Independent Design Peer Review

CROWN STREET, SURRY HILLS DEVONSHIRE ST TO OXFORD ST UPGRADE PEER REVIEW

CITY OF SYDNEY
MARCH 2023
FINAL

STATUS	FINAL
ISSUE	D
DATE	03,03,2023
PREPARED BY	GJ/ZY
APPROVED BY	JP

Crown Street Peer Review Plan 5 of 8

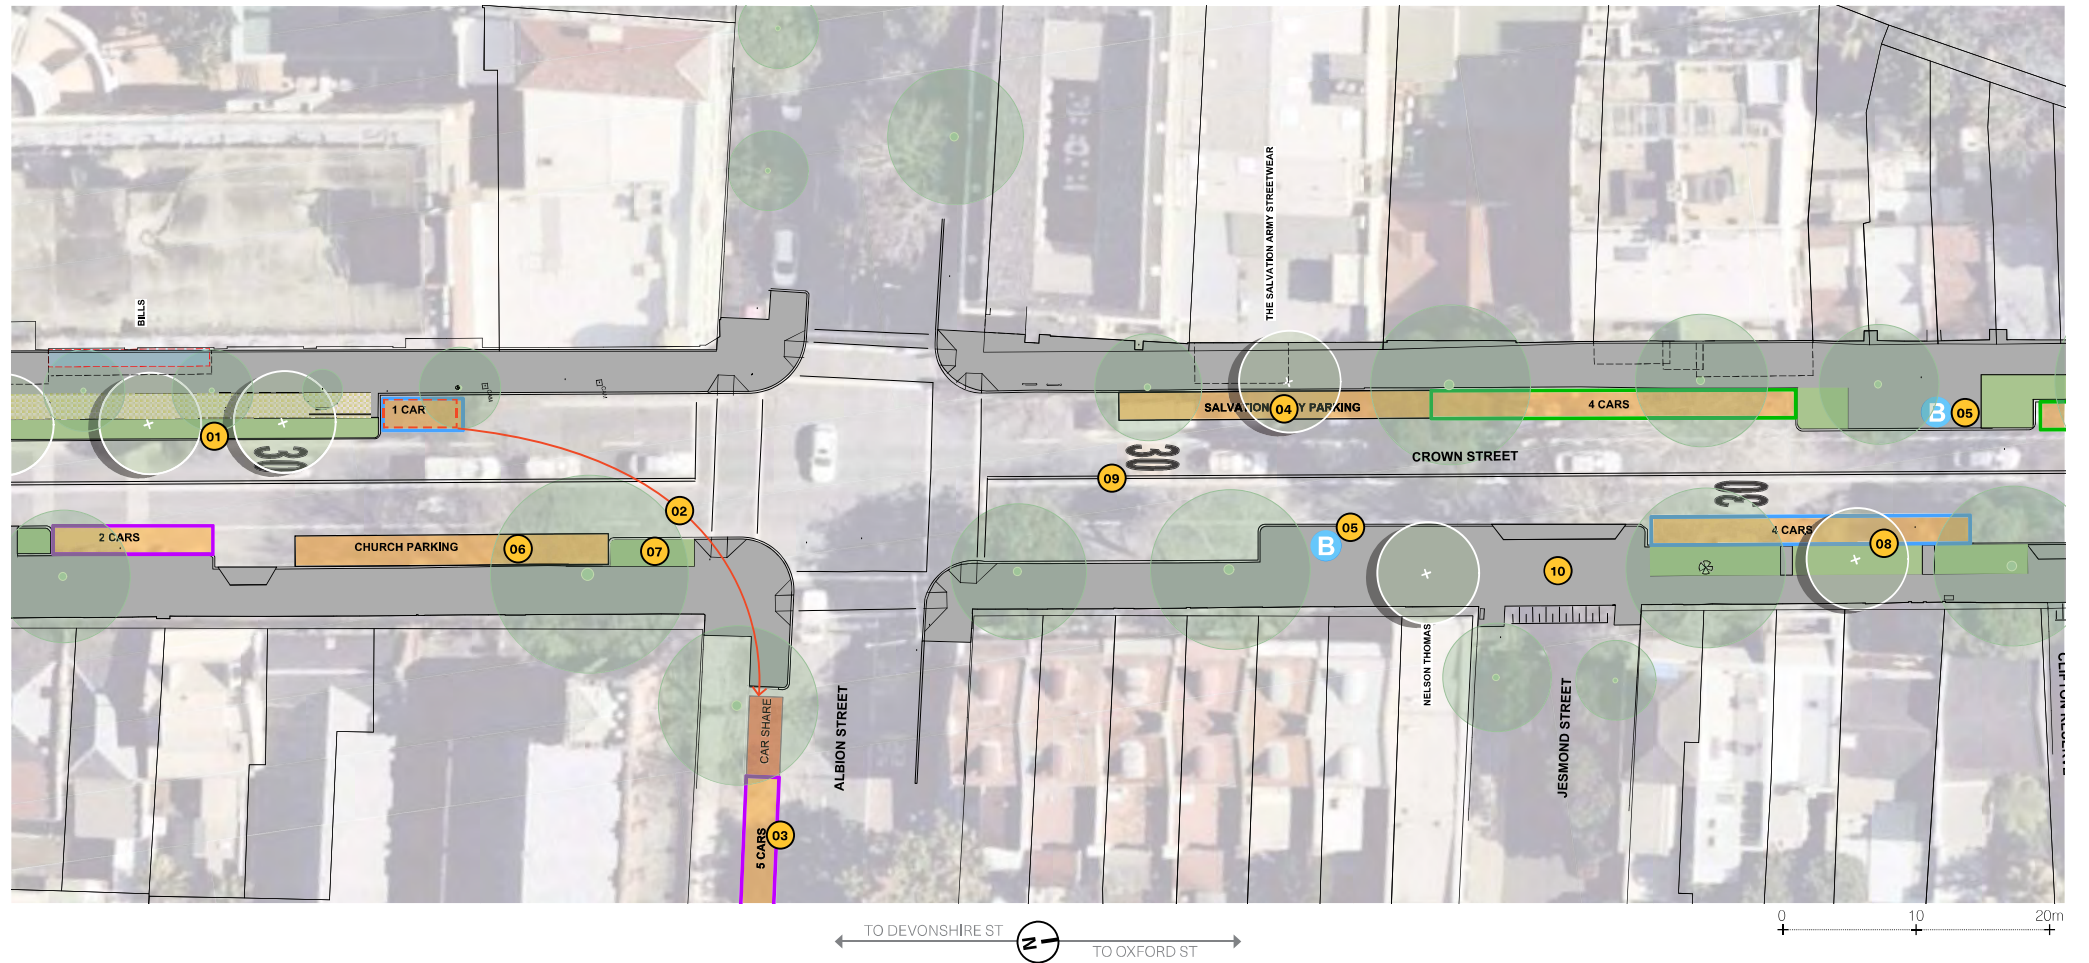
1. New kerb extension to create activation area with kerbside planting and additional street trees at existing commercial premises.
2. 1x car share relocated to Albion St, replaced with 2P parking space.

3. Convert 6 no. existing unmarked 2P parking spaces on Albion St to 5 no. marked 2P parking spaces.
4. Existing Salvation Army parking area. Investigate opportunity to introduce Loading Zone and/or after-hours general parking (subject to further consultation).

5. New kerb extension for in-lane bus stop, 9m paving zone shown, to be reviewed at detailed design stage to consider user access requirements (subject to approval by TfNSW).

6. Existing signed church parking area. Investigate opportunity to introduce timed after-hours general parking (subject to further consultation).
7. Kerb extension to provide additional pedestrian paving and planting at intersection.

8. Kerb alignment adjusted (to minimum compliant parking space width) to maximise footpath and planting space. Continuous planting bed provided with intermittent pavements for access to parked vehicles.

9. Speed reduction to Crown Street to 30km/h (subject to TfNSW approval).
10. Continuous footpath treatment and kerb extension at Jesmond St.

Crown Street Peer Review Plan 6 of 8

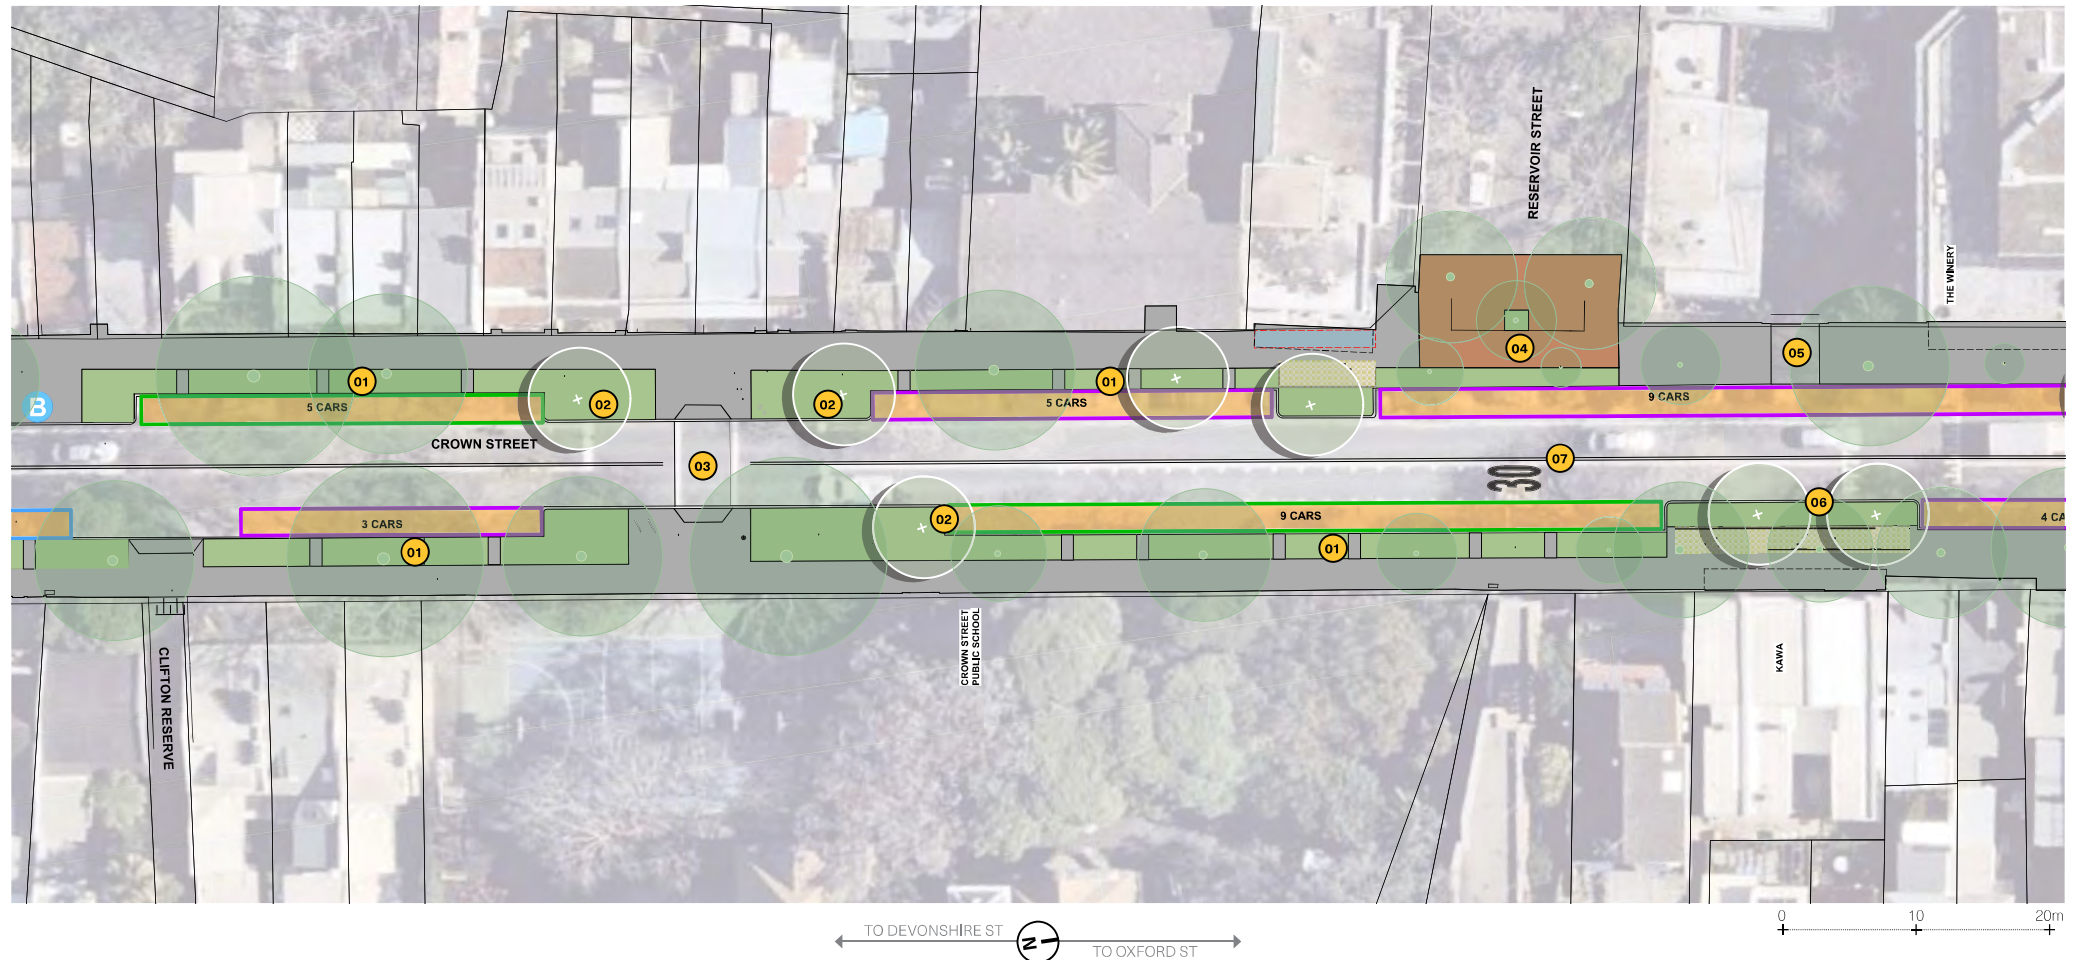
1. Kerb alignment adjusted (to minimum compliant parking space width) to maximise footpath and planting space. Continuous planting bed provided with intermittent pavements for access to parked vehicles.
2. New kerb extension with planting and street trees to provide additional canopy cover.
3. Existing signalised crossing retained in current location.
4. Existing brick paving to full width of Reservoir St lot boundary to be retained.
5. Existing heritage driveway retained.
6. New kerb extension to create activation area with kerbside planting and additional street trees at existing commercial premises.
7. Speed reduction to Crown Street to 30km/h (subject to TfNSW approval).
